Draft Informal document GRSP-62-15 Rev.1
(62nd GRSP, 11 - 15 December 2017,
agenda item 3(a))

Draft amendment 2 – Revision 1

Submitted by the Informal Working Group on global technical regulation No. 9

"Figure 5A

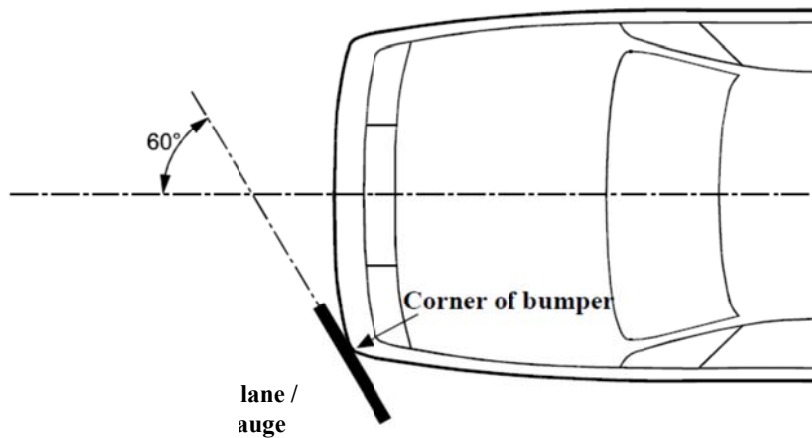
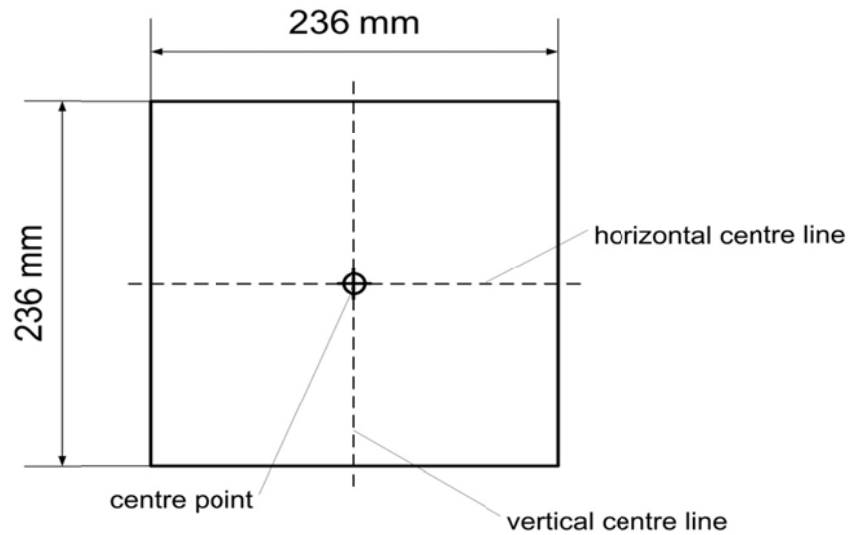
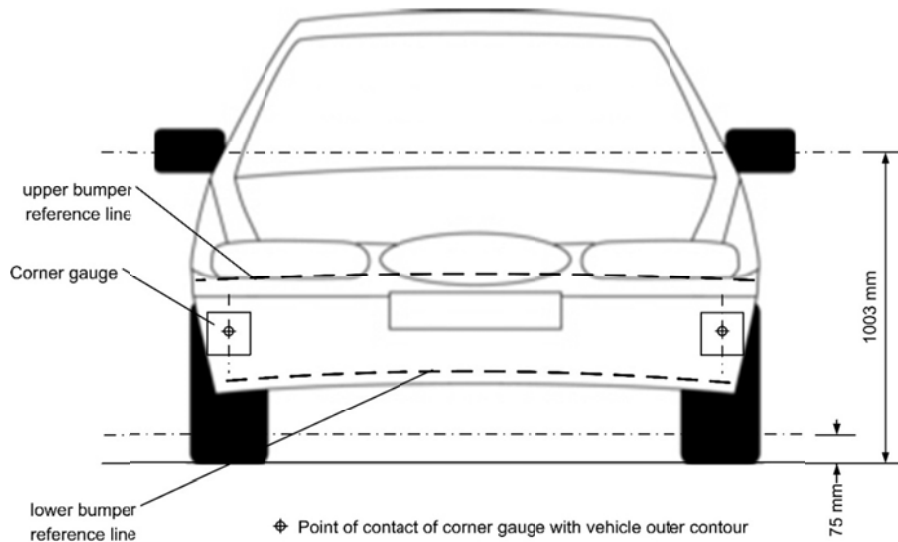
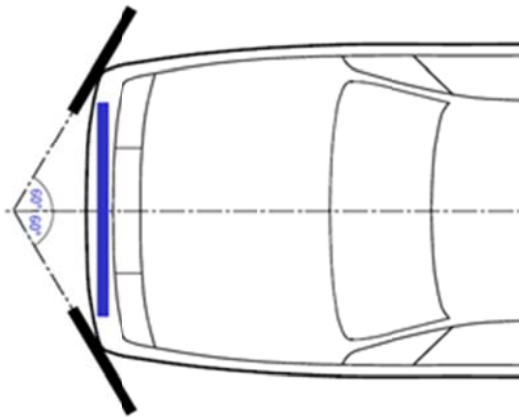
"3.14. **"Corner of bumper"** means **the transversal position of the vehicle's point of contact with a vertical plane which makes an angle of 60° with the vertical longitudinal plane of the vehicle and is tangential to the outer surface of the bumper (see Figure 5)-corner gauge as defined in Figure 5B.**

For determination of the corner of bumper, the front surface of the corner gauge is moved parallel to a vertical plane with an angle of 60° to the vertical longitudinal centre plane of the vehicle (see Figures 5A and 5C) at any height of the centre point of the corner gauge between:

- (a) **Equal to and above the point found on the vertical line intersecting the Lower Bumper Reference Line at the assessment position in transversal direction or at 75 mm above the ground reference plane, whichever is higher.**
- (b) **Equal to and below the point found on the vertical line intersecting the Upper Bumper Reference Line at the assessment position in transversal direction or at 1,003 mm above the ground reference plane, whichever is lower.**

Figure 5, amend to read:

"Figure 12
Flexible lower legform impactor: Dimensions and centre of gravity locations of femur, knee joint and tibia (side view)

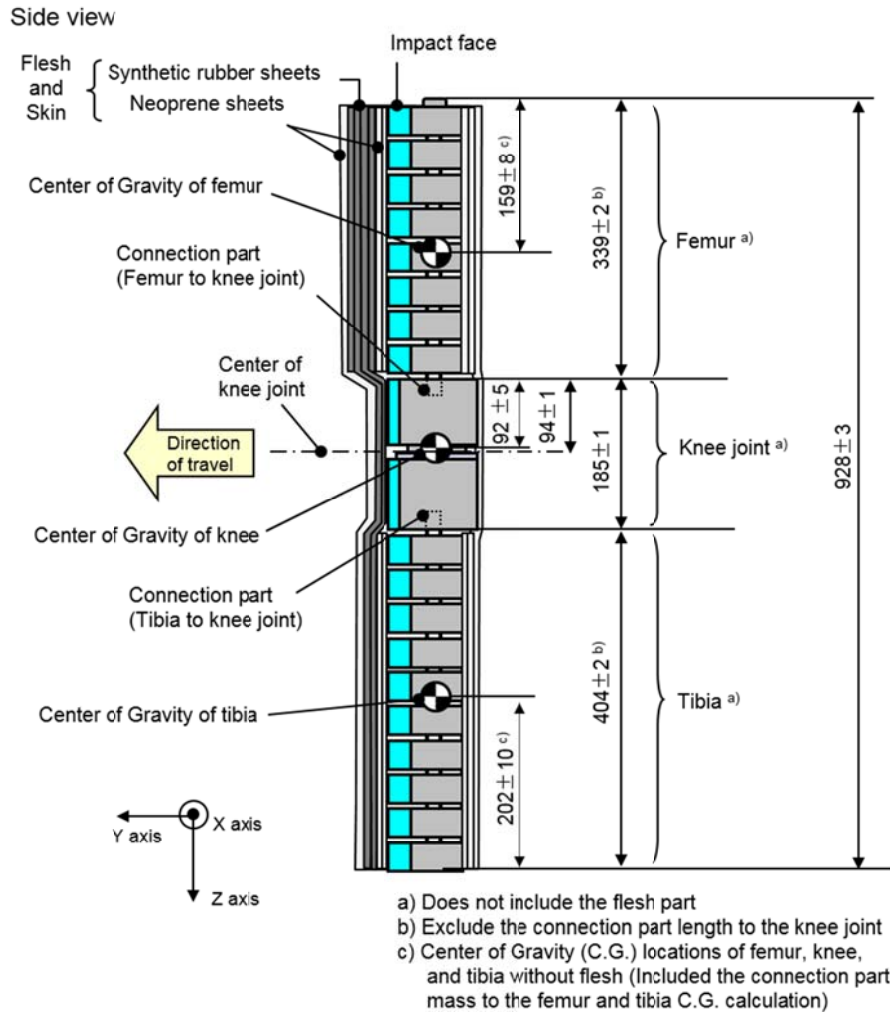
The flexible lower legform impactor shall consist of the flesh and skin, ~~the~~ flexible long bone segments (representing ~~the~~ femur bone and ~~the~~ tibia bone), and the knee joint as shown in Figure 12¹.

The centres of gravity of the femur and tibia without the flesh and skin, including the connection parts to the knee joint, shall be as defined 159 ± 8 mm and 202 ± 10 mm respectively from the top, but not including the connection part to the knee joint, of each part as shown in Figure 12. The centre of gravity of the knee joint shall be as defined 92 ± 5 mm from the top of the knee joint as shown in Figure 12.

Figure 12, shall be deleted:

Insert new Figures 12 to 16, to read:

Figure 13
 Flexible lower legform impactor: Schematic plan views of femur, tibia, and knee dimensions (top view, main body segments)

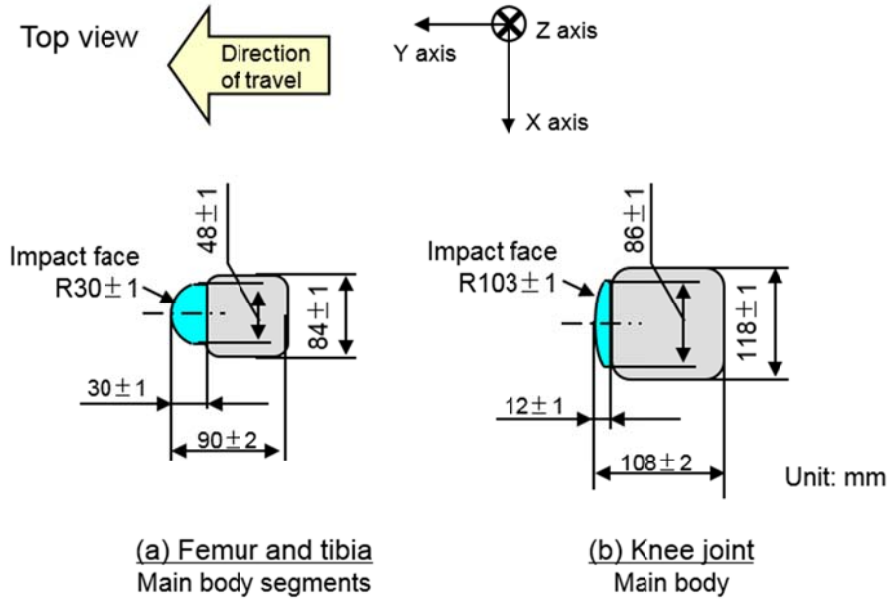
- "6.3.1.1.1. **The cross-sectional shape of the femur main body segments, the tibia main body segments and their impact faces shall be as defined perpendicular to the Z-axis of the femur and the tibia main body segments shall be 90 mm in width along the Y-axis, and 84 mm in width along the X-axis as shown in Figure 13 (a). The impact face shall be 30 mm in radius, 30 mm in width along the Y-axis, and 48 mm in width along the X-axis as shown in Figure 13 (a).**

- 6.3.1.1.2. **The cross-sectional shape of the knee joint and its impact face shall be as defined perpendicular to the Z-axis of the knee joint shall be 108 mm in width along the Y-axis, and 118 mm in width along the X-axis as shown in Figure 13 (b). The impact face shall be 103 mm in radius, 12 mm in width along the Y-axis, and 86 mm in width along the X-axis as shown in Figure 13 (b).**

Figure 14
 Flexible lower legform impactor: Flesh and skin dimensions

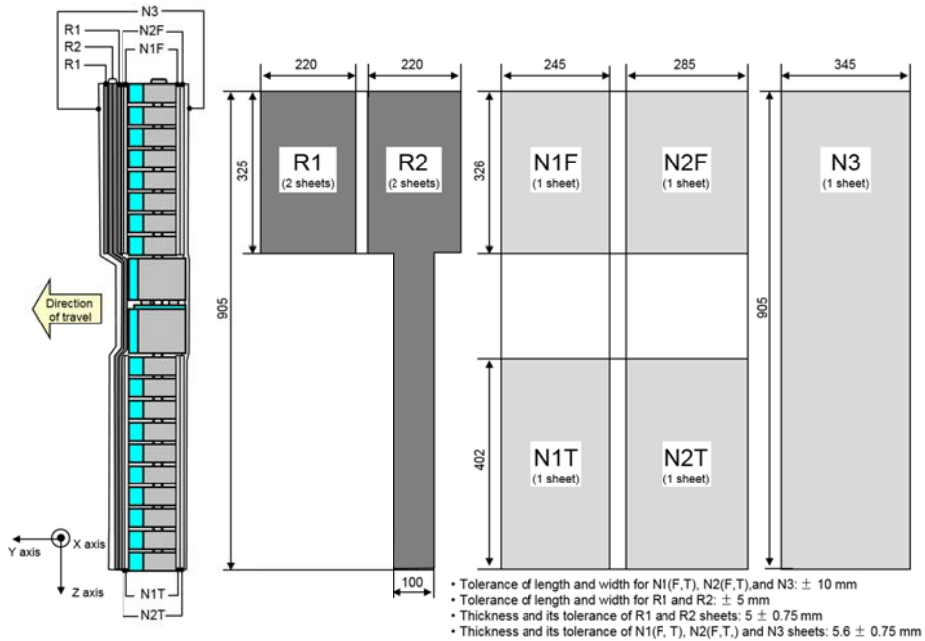
sheets (R1, R2) and foamed neoprene sheets (N1F, N2F, N1T, N2T, N3) as shown in Figure 14. The size of the sheets shall be within the requirements described in Figure 145. The sheets are required to have compression characteristics as shown in Figure 15. The compression characteristics shall be checked using material from the same batch as the sheets used for the impactor flesh and skin.

Figure 16
Flexible lower legform impactor: Instrument Location of the transducers

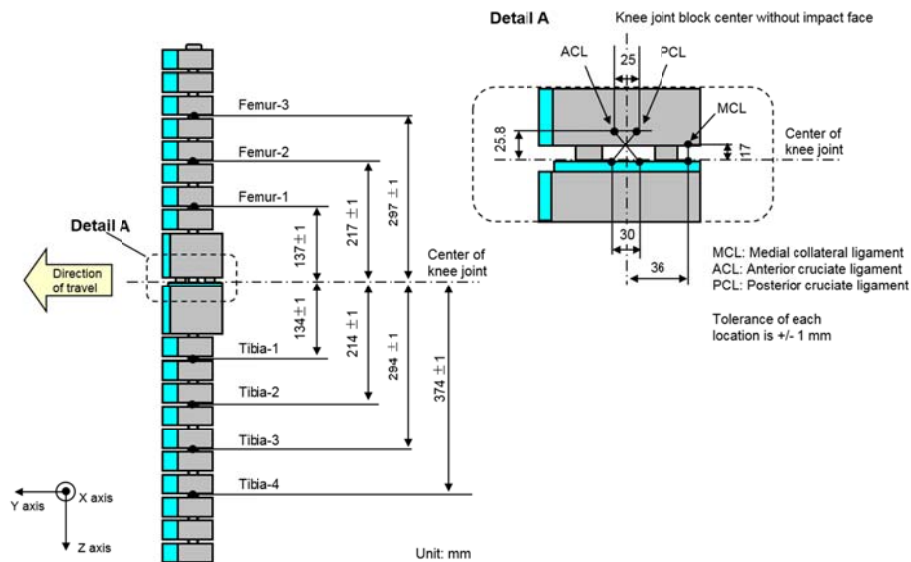
- 6.3.1.1.6.1. Four transducers shall be installed in the tibia to measure bending moments at locations within the tibia. ~~The sensing locations of each of the transducers are as follows: tibia 1: 134 mm, tibia 2: 214 mm, tibia 3: 294 mm and tibia 4: 374 mm below the knee joint centre respectively as shown in Figure 16.~~

~~Three transducers shall be installed in the femur to measure bending moments applied to the femur. The sensing locations of each of the transducers are as follows: femur 1: 137 mm, femur 2: 217 mm and femur 3: 297 mm above the knee joint centre, respectively, as shown The sensing locations of each of the transducers are as defined in Figure 16.~~

"Figure 20

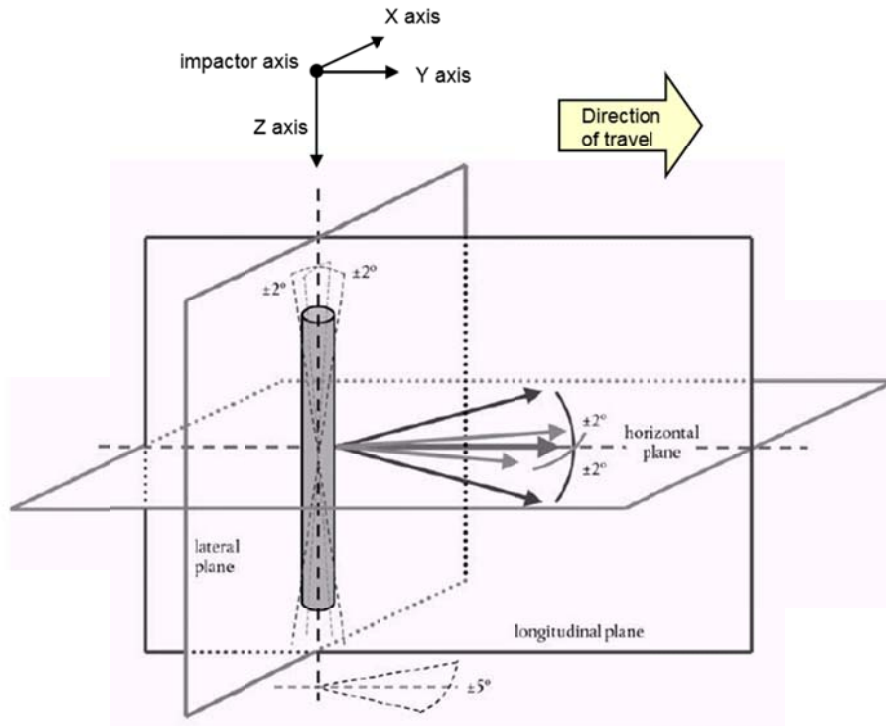
7.1.1.2. **The direction of the impact velocity vector shall be in the horizontal plane and parallel to the longitudinal vertical plane of the vehicle. The tolerance for the direction of the velocity vector in the horizontal plane and in the longitudinal plane shall be $\pm 2^\circ$ at the time of first contact. The axis of the impactor shall be perpendicular to the horizontal plane, with a roll and pitch angle tolerance of $\pm 2^\circ$ in the lateral and longitudinal plane. The horizontal, longitudinal and lateral planes are orthogonal to each other (see Figure 20).**

- 7.1.1.3.2. **At the time of first contact the impactor shall have the intended orientation about its vertical axis, for the correct operation of its knee joint, with a yaw angle tolerance of $\pm 5^\circ$ (see Figure 20).**

Figure 21

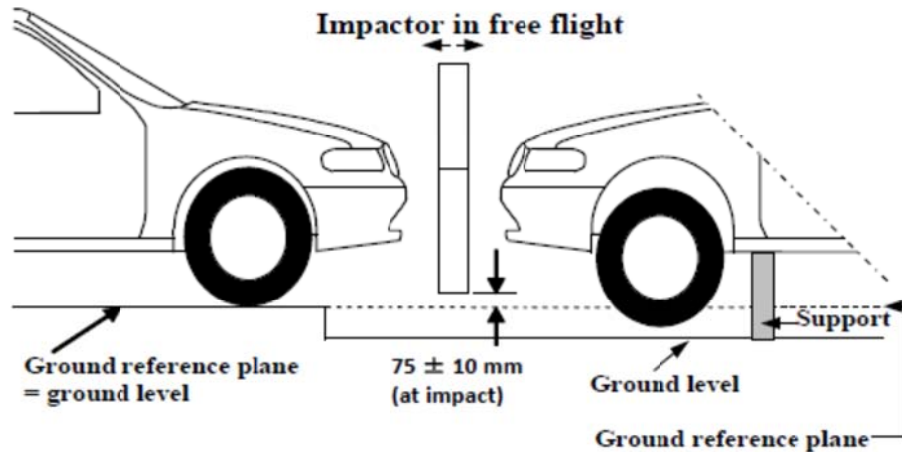
7.1.1.3. **The bottom of the impactor (without parts needed for the purposes of launching and/or protection) shall be 75 mm above the ground reference plane at the time of the first contact with the bumper (see Figure 21), with a tolerance of ± 10 mm. When setting the height of the propulsion system, an allowance ~~must~~**shall** be made for the influence of gravity during the period of free flight of the impactor.**

Figure 22

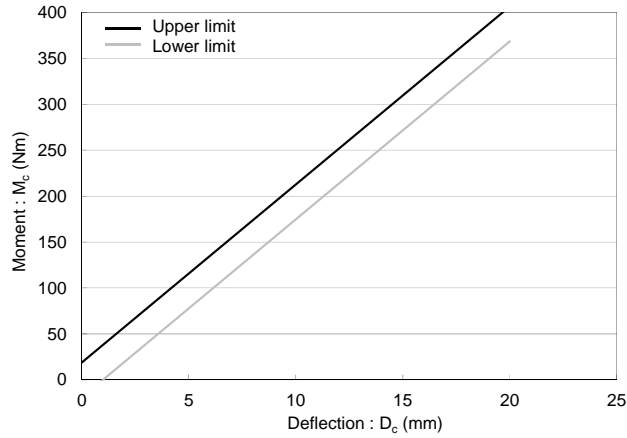
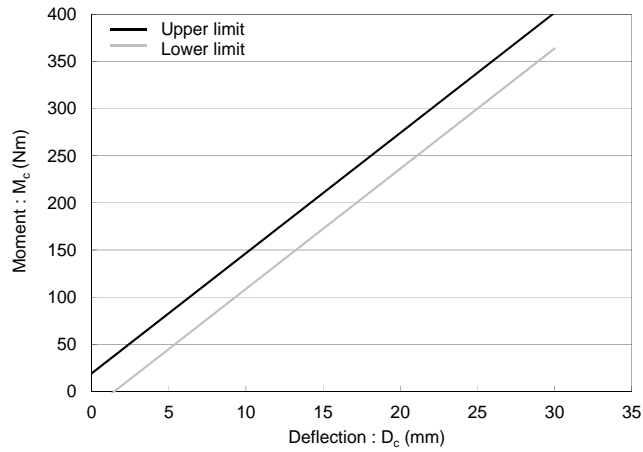
- 8.1.1.2. **When the femur and the tibia of the impactor, *without flesh and skin*, are loaded in bending in accordance with paragraph 8.1.1.4., the applied moment and the generated deflection at the centre of the femur and the tibia (M_c and D_c) shall be within the corridors shown in Figure 22.**

Figure 23
Flexible lower legform impactor: Requirement corridors for the knee joint, without flesh and skin, in the static certification test (see paragraph 8.1.1.3.)

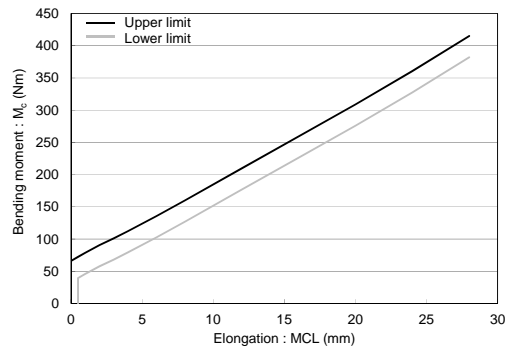
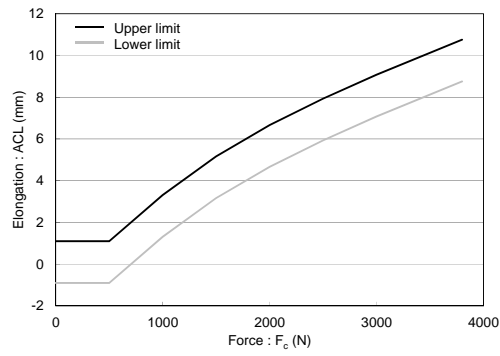
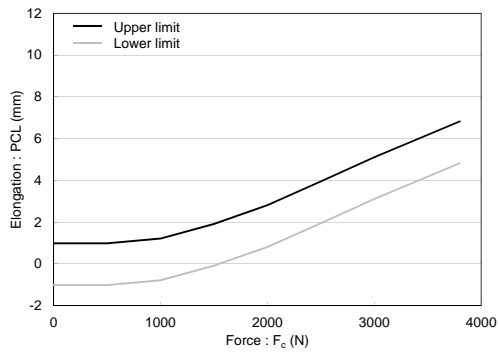
- 8.1.1.3. **When the knee joint of the impactor, *without flesh and skin*, is loaded in bending in accordance with paragraph 8.1.1.5., the MCL, ACL, and PCL elongations and applied bending moment or the force at the centre of the knee joint (M_c or F_c) shall be within the corridors shown in Figure 23.**

Figure 24
Flexible lower legform impactor: Impactor-t Test set-up for the femur in the static certification test (see paragraph 8.1.1.4.)

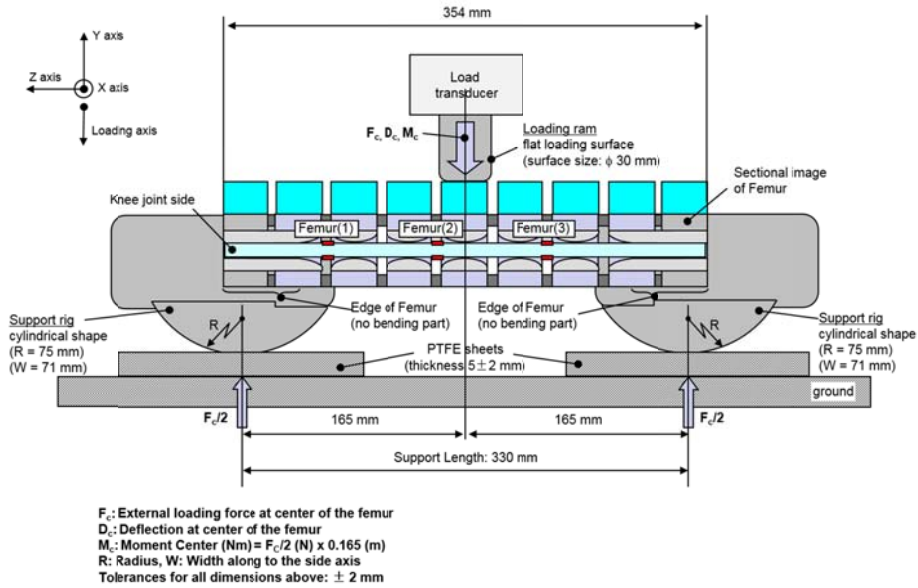
- 8.1.1.4. **The edges of the femur and tibia, *without flesh and skin*, not bending parts, shall be mounted to the support rig firmly as shown in Figure 24 and Figure 25. The Y-axis of the impactor shall be parallel to the loading axis within $180 \pm 2^\circ$ tolerance. To obtain repeatable loading, low friction Polytetrafluoroethylene (PTFE) plastic pads are used under each support (see Figures 24 and 25).**

Figure 26
Flexible lower legform impactor: Test set-up for the knee joint in the static certification test (see paragraph 8.1.1.5.)

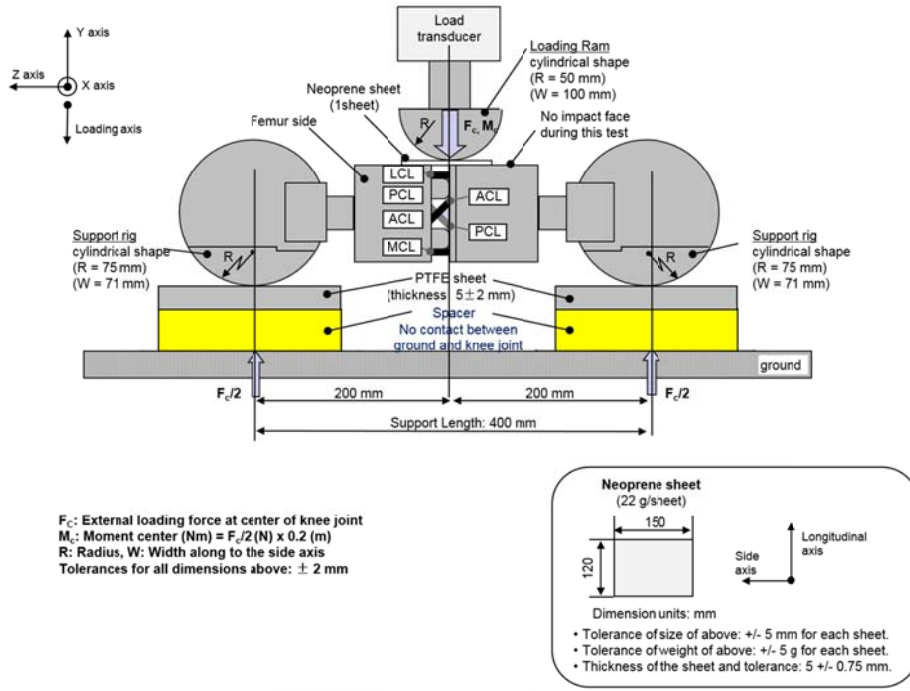
- 8.1.1.5. **The ends of the knee joint, without flesh and skin, shall be mounted to the support rig firmly as shown in Figure 26. The Y-axis of the impactor shall be parallel to the loading axis within $\pm 2^\circ$ tolerance. To obtain repeatable loading, low friction Polytetrafluoroethylene (PTFE) plastic pads are used under each support (see ~~f~~Figure 26). To avoid impactor damage, a foamed neoprene sheet shall be set ~~underneath~~ **between** the loading ram and the impactor face of the knee joint, which is described in ~~the~~ **Figure 1326**, shall be removed. The foamed neoprene sheet used in this test shall have compression characteristics as shown in Figure 15.**

The centre of the loading force shall be applied at the knee joint centre within $\pm 2^\circ$ mm tolerance along the Z-axis (see ~~f~~Figure 12). The external load shall be increased so as to maintain a deflection rate between 10 and 100 mm/minute until the bending moment at the centre part of the knee joint (M_c) reaches 400 Nm.

Figure 27
Flexible lower legform impactor: Test set-up for the dynamic lower legform impactor certification test (pendulum test, see paragraph 8.1.2.4.)

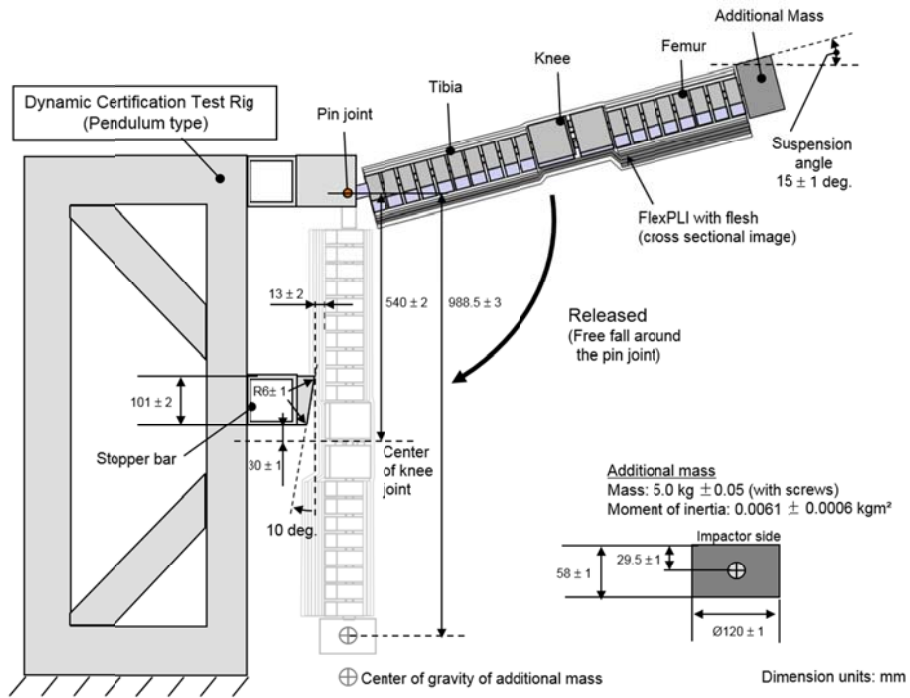
- 8.1.2.4.1. **The flexible lower legform impactor, including the flesh and skin, shall be suspended from the dynamic certification test rig $15 \pm 1^\circ$ upward from the horizontal as shown in Figure 27. The impactor shall be released from the suspended position and fall freely against the pin joint of the test rig as shown in Figure 27.**

- 8.1.2.4.2. **The knee joint centre of the impactor shall be 30 ± 1 mm below the bottom line of the stopper bar, and the tibia impact face without the flesh and skin shall be located 13 ± 2 mm from the front upper edge of the stopper bar when the impactor is hanging freely as shown in Figure 27.**

Figure 28

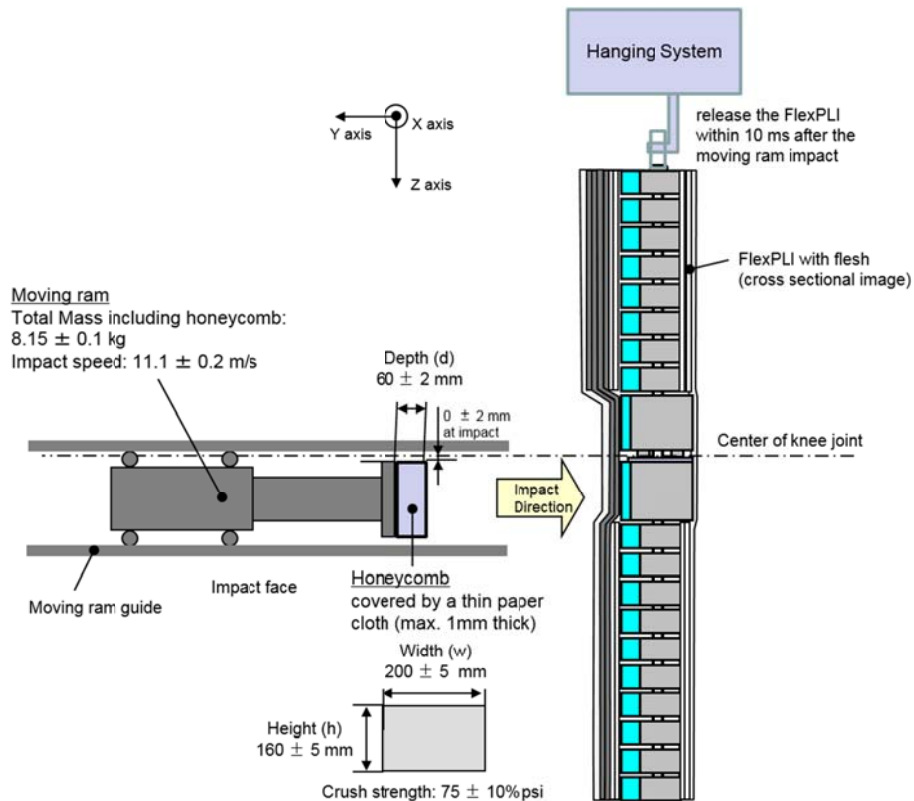
- 8.1.3.4. Test procedure
- 8.1.3.4.1. The assembled flexible lower legform impactor (with the flesh and skin) shall be hung vertically and freely suspended from a test rig as shown in Figure 28. It is then impacted by the upper edge of a linearly guided aluminium honeycomb impactor, covered by a thin paper cloth with a maximum thickness of 1 mm, at an impact speed of 11.1 ± 0.2 m/s. The legform shall achieve a free flight condition within 10 ms after the time of first contact of the honeycomb impactor.

- 8.1.3.4.4. At the time of the first contact, the flexible lower legform impactor pitch angle (rotation around the Y-axis) and, therefore, the pitch angle of the velocity vector of the honeycomb impactor shall be within a tolerance of $\pm 2^\circ$ in relation to the lateral vertical plane. The flexible lower legform impactor roll angle (rotation around the X-axis) and, therefore, the roll angle of the honeycomb impactor shall be within a tolerance of $\pm 2^\circ$ in relation to the longitudinal vertical plane. The flexible lower legform impactor yaw angle (rotation around the Z-axis) and, therefore, the yaw angle of the velocity vector of the honeycomb impactor shall be within a tolerance of $\pm 2^\circ$.
